গণপ্রজাতন্ত্রী বাংলাদেশ সরকার
শ্রম ও কর্মসংস্থান মন্ত্রণালয়
কলকারখানা ও প্রতিষ্ঠান পরিদর্শন অধিদপ্তর

ক্যাপ পর্যবেক্ষণের তথ্য

কারখানার নাম	কতুল্লা, এয়াপবেলস
ঠিকানা	B-68/1 Wapda Road, Jalkuri, Siddirganj, Narayanganj
কারখানার কোড	NRY087
কালার কোড	
মূল্যায়নের ধরণ: কাঠামোগত মূল্যায়ন	পর্যবেক্ষণের তারিখ: ০১-০২-২০২৩
১. পর্যবেক্ষণ

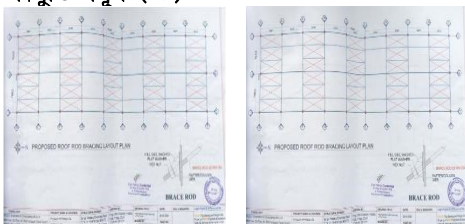
পরিদর্শন পর্ববেষ্টিত	During inspection, bracing for lateral stability in 1st and GF was not found.
ক্যাপ আইটেম ক্যাটাগরি

কার্যক্রম	Verify the lateral stability of the structure and confirm the requirement of any bracing of the structure.
সুপারিশের তথ্যসূত্র	
কারখানার কার্যক্রম	We have already engaged consultant to verify lateral stability of the structure to confirm the requirement of any bracing of the structure.
অগ্রাধিকার	৬ সপ্তাহ
চূড়ান্ত সময়সীমা	১৫-০৯-২০১৬
সংশোধিত সময়সীমা	০১-০১-১৯৭০
অগ্রগতির অবস্থা	চলমান
মন্তব্য	27-10-2020, They have already talk to their consultant engineer to verify lateral stability of the structure. 13.01.2021-During inspection, bracing for lateral stability in 1st and GF was not found. But they have already talk to their consultant engineer to verify lateral stability of the structure. 03-06-2021 (CVV4) : During inspection, bracing for lateral stability in 1st and GF was not found. But they have already talk to their consultant engineer to verify lateral stability of the structure but not yet. 24-Aug-2021 (CVV5) : As-built architectural drawing, structural drawing & DEA report have been prepared and submitted to DIFE for approval ,only submission letter of that is available. 28-Aug-2022: After Submission of DEA report DIFE have some correction. Factory management says that, they has been start to work this correction & Corrected DEA report will submit to DIFE as soon as possible. Proposed Bracing layout plan & sectional drawing found on site during visit. 01-Feb-2023: After Submission of DEA report DIFE have some correction. Factory management says that, they has been start to work this correction & Corrected DEA report will submit to DIFE as soon as possible.
